To: Dan Fisk, Paramounte Engineering
From: Brian Chambers, Senior Planner; 910.342.2782
CC: File;
Date: 4/14/2021
Re: Wilmington Three Phase A TRC Rev 2

Engineering has reviewed the plans for the Wilmington Three Phase A project submitted March 26, 2021 and have the following comments:

Engineering has reviewed the landscape plans for the Wilmington Three Phase A project submitted March 8, 2021 and have the following comments:

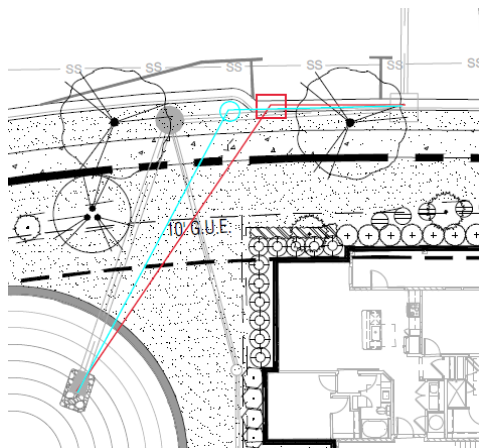
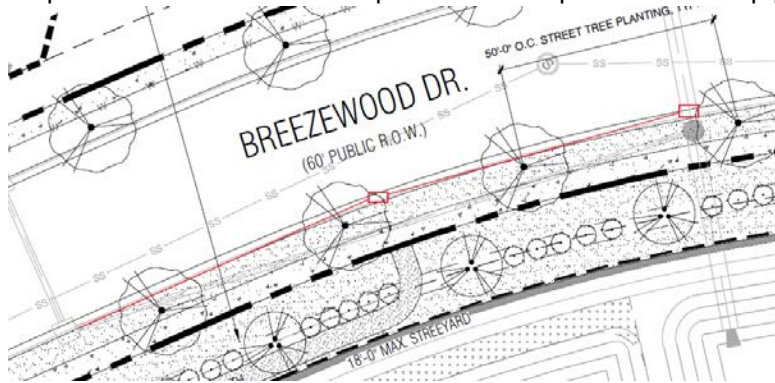
1. L3.1: Pipes will need to be realigned and structures added/modified to stay out of the planting strip. Cannot allow trees to be planted over top of stormdrain piping.

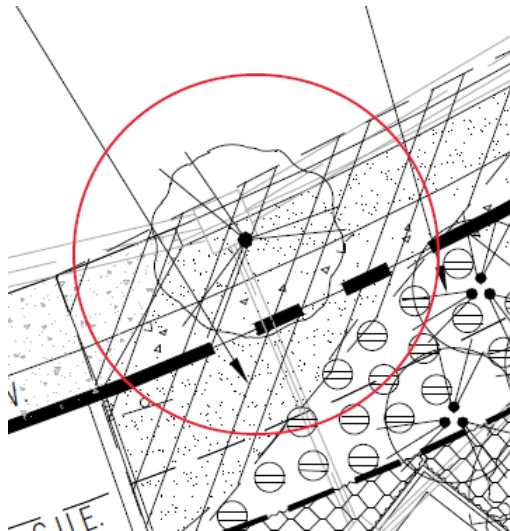
2. L3.2: Street tree is located too close to the inlet:

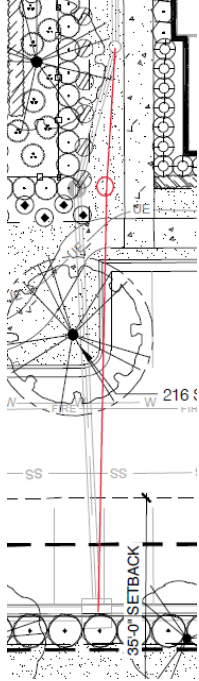
3. L3.4: Shift YD-310 to put the pipe out from under the tree in the corner.

Wilmington Three Ph A (Barclay Apartments Phase 1) Standard Street Lighting Plan

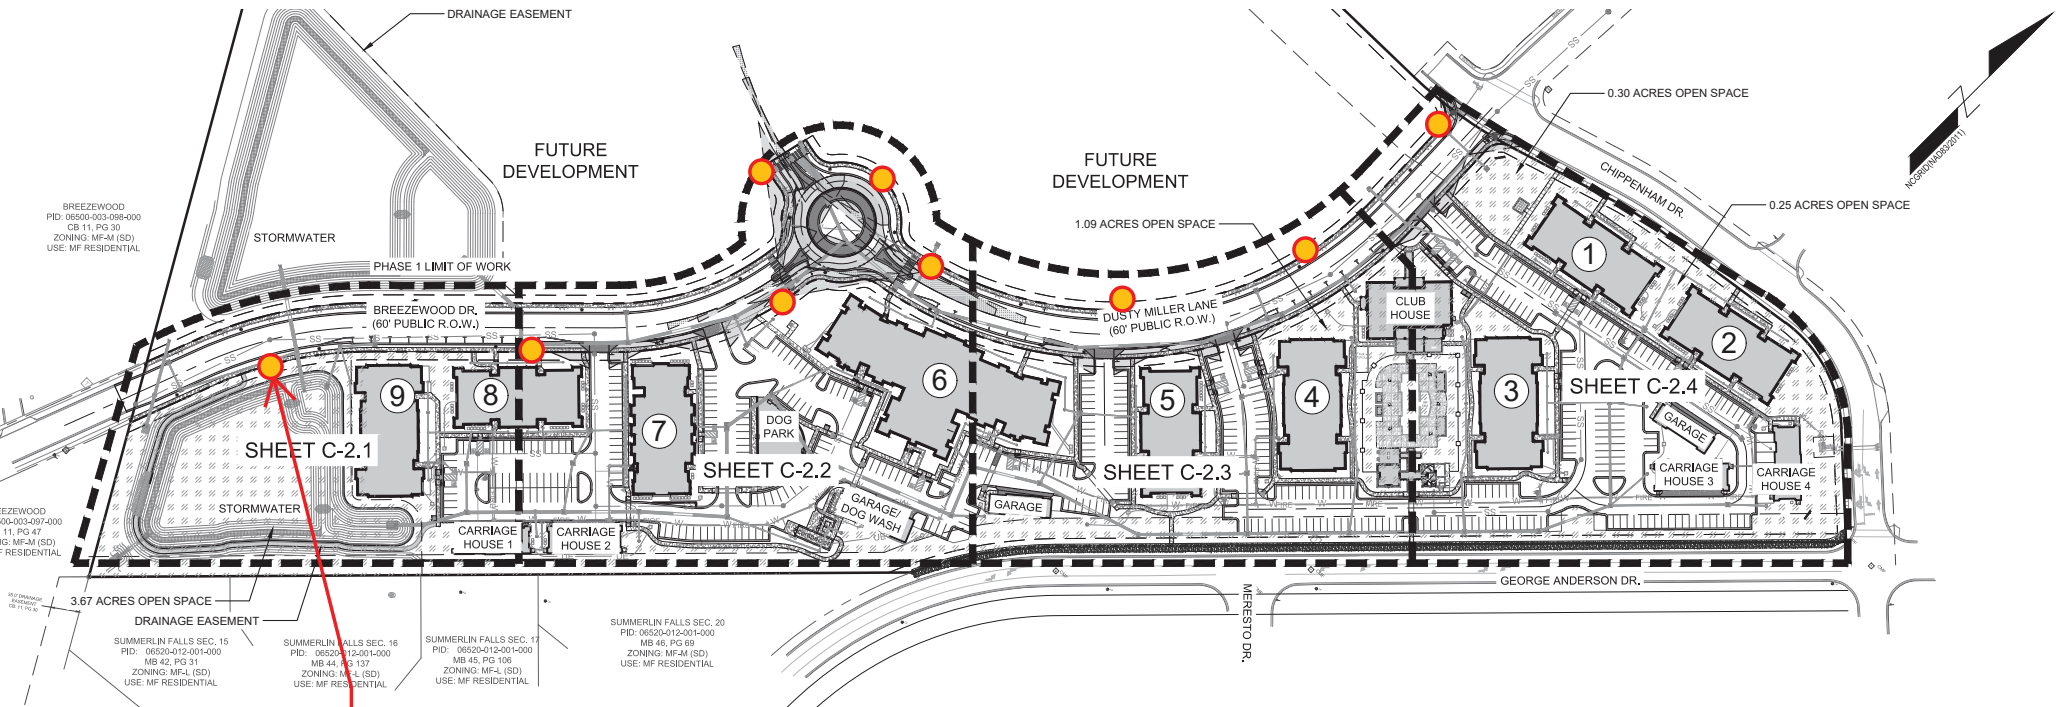
LED 50 at this location shall be installed at approximately 300' from the nearest existing standard streetlight on developed section of Breezewood Dr.
